## Technical Service Bulletin

**MODEL(S) AFFECTED:** **T300/T300e Magnetic Single Disk Models**

**SUBJECT:** The magnetic pad driver/brush may possibly disengage if machine is operated on uneven floor surfaces with low down pressure.

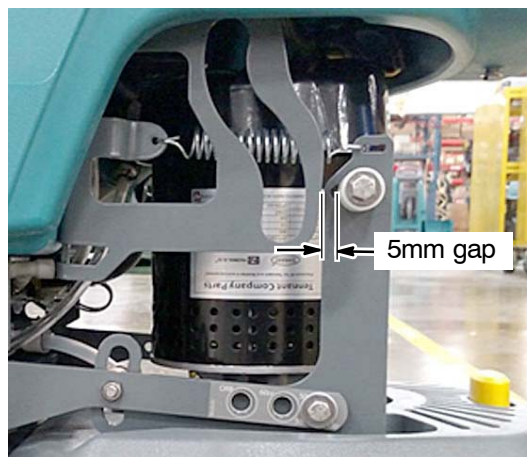
**PURPOSE:** To prevent the magnetic pad driver/brush from disengaging in this condition, perform the following procedure.

1. Lower scrub head and remove front shroud.
2. Remove existing spring from head lift bracket and install lighter spring p/n 1032420.
4. With the scrub deck in the lowered position, slide the head lift glide back until there is a 5mm gap between the head lift bracket and glide. Re-tighten nut.

3. Using a 13mm wrench, loosen the nut on the head lift glide.
